RE: RESPONSE TO FURTHER ADVICE FOR PROPOSED MATERIAL CHANGE OF USE FOR A MULTIPLE DWELLING UPON LAND LOCATED AT 81 YORK STREET, INDOOROOPILLY QLD 4068 - COUNCIL FILE REFERENCE A006928376.

Enc. *Response to Further Advice*

Figure 2: Rear deep planting cross-section.

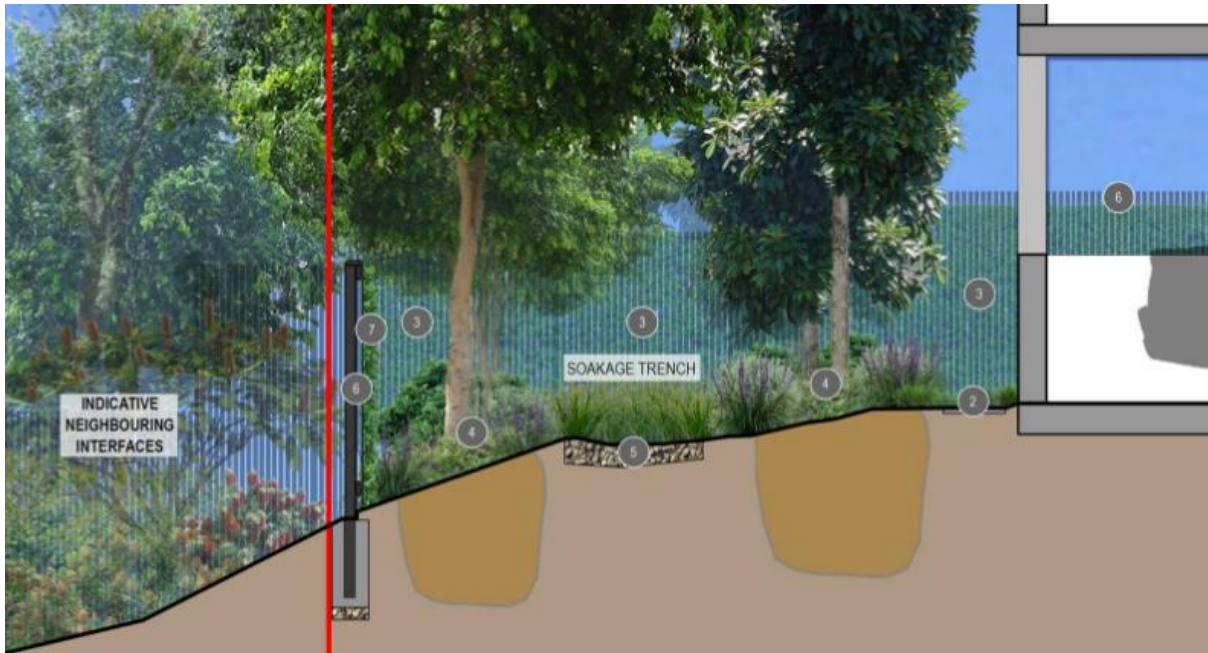
4. The plans show a 15m² hatched blue area within the rear deep planting area. It is unclear what this area is.
 - a. Provide amended plans removing any proposed structures or services from deep planting areas.

Please be advised that the blue hatched area as indicated on the on the Architectural Proposal Plans (drawing number SK101) is a stormwater soakage trench, as detailed within the Stormwater Management Plan prepared by MPN Consulting and submitted as part of the original application material. Importantly, the soakage trench acts as the emergency overflow discharge point for the eastern roof catchment stormwater detention tank. Please see the Stormwater Layout & Catchment Plan (drawing numbers DA.03 & DA.04) prepared by MPN Consulting for further detail.

It is also noted that the Landscape Concept Plan (Section AA – DWG# SK020) identifies the soakage trench. While the primary function of the trench is for stormwater overflow, the soakage pit will also improve irrigation for trees surrounding the pits and is not considered to be significant infrastructure.
